FINAL SITE PLANS

ALTA VISTA AT ST. JOSEPH'S  
PARK

**Re: ALTA Vista  
Site Plan Review  
PRC Response to Comments**

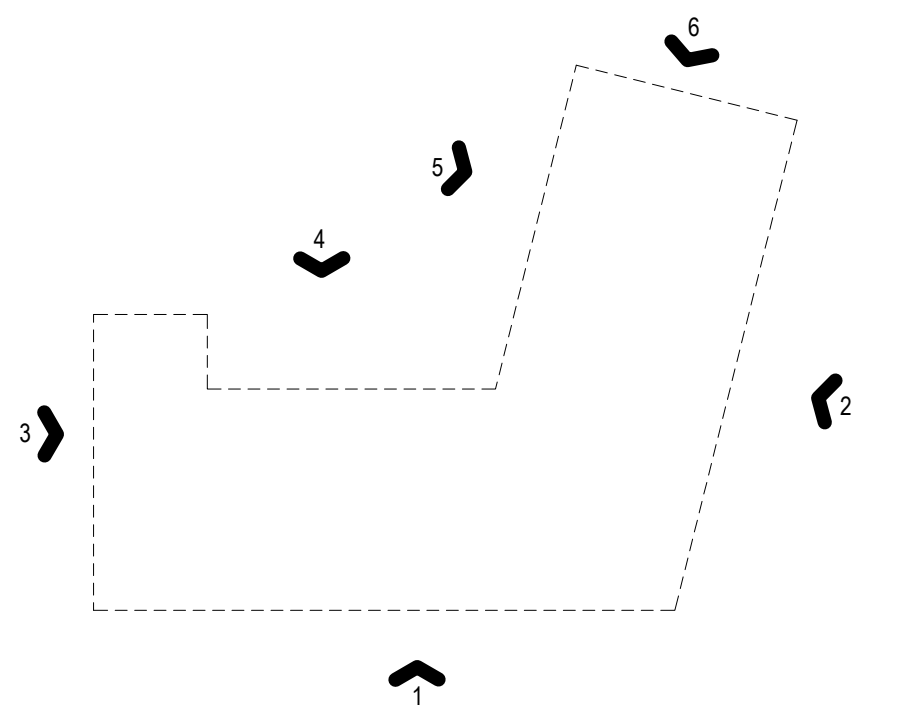
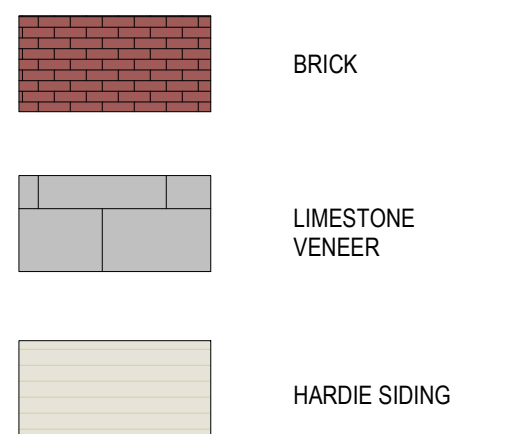
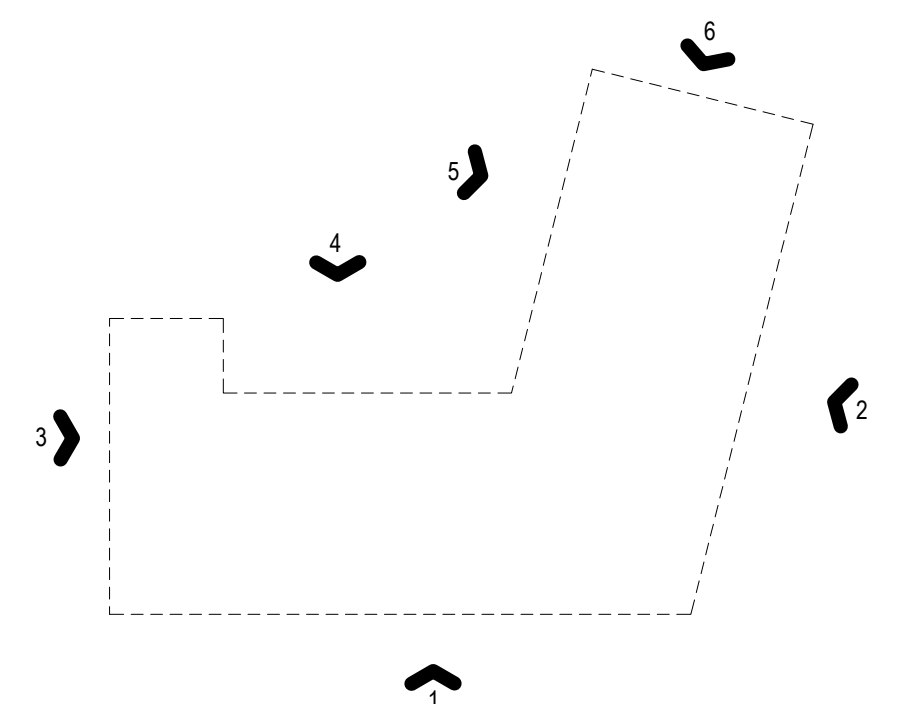
- 1) Revise building design accordingly.

- 1) Provide renderings that demonstrate how the proposed building, specifically the west façade relates to the adjacent landmark site. Be sure to include any other improvements that strengthen the connection between the two structures.

- 2) Provide an entrance to the commercial space with direct pedestrian access from the street.

The PRC is unable to comment on the brick pilasters with the provided renderings and thus requests new renderings in order to determine if their massing is satisfactory or whether a modification or alternative is preferable.

The height of the cornice was increased at the projecting portions of the façade, defined by the piers extending the full six stories, to create a vertical delineation in two locations on each facade. The 6-story stone corner element was expanded on both Pleasant and Franklin Streets to provide an even stronger presence.

The transparency for the street facades was increased from 23% to 33.9%. Any additional changes to the window pattern would disrupt and draw unwanted attention. More importantly, as a residential building, safety and privacy are important to tenants that have apartments along the first floor. The double doors were removed at the street level and changed to double casements instead to help with security and also control possible dust and snow concerns at the grade plane. Additional windows were also added to the North façade.

Additional windows were added to the South West corner of the West façade as suggested in the review. Additional windows were added to the second floor of the commercial space to create more transparency. Additional windows were also added to the North façade.

Additional windows were added to the first and second floor of the commercial space to provide a better visual connection to St. Joseph Church. The existing walkway will have dedicated lighting to create a guided pathway between the commercial space and St. Joseph's Church.

The 6-story stone corner element was expanded on both Pleasant and Franklin Streets to provide an even stronger presence with additional transparency added.

It is the belief of the project team that the stepping of the façade and brick pilasters due their part to provide vertical articulation of the façade during the daylight hours and will have lighting to provide that effect at night.
